RE: 9.3.3 Report ADM-2025-025 Reporting Out from Council Direction Update

RE: **ARA Site Plan Amendment (ERO # 025-0476) - 7034 Concession 2, Puslinch**

RE: ARA Site Plan Amendment (ERO # 025-0235) - 7034 Concession 2, Puslinch

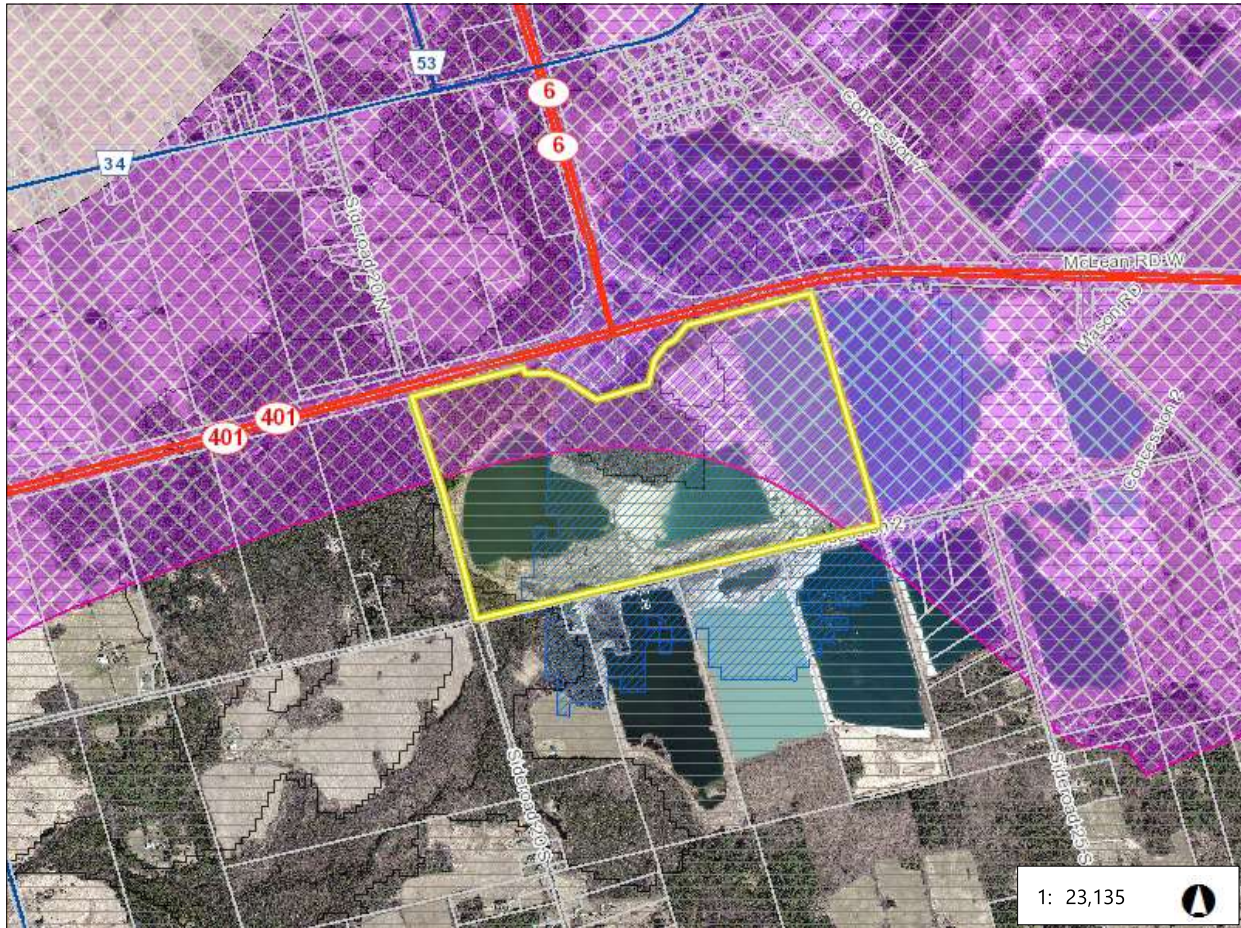
The subject property is located in:

- a) a Significant Groundwater Recharge Area (SGRA);

- b) a draft Wellhead Protection Area Q (WHPA-Q) with a significant risk level; and
- c) a Highly Vulnerable Aquifer (HVA).

Attachments show the relevant mapping. Please note the subject property is not located in an Issue Contributing Area (ICA) or a Wellhead Protection Area for Quality.
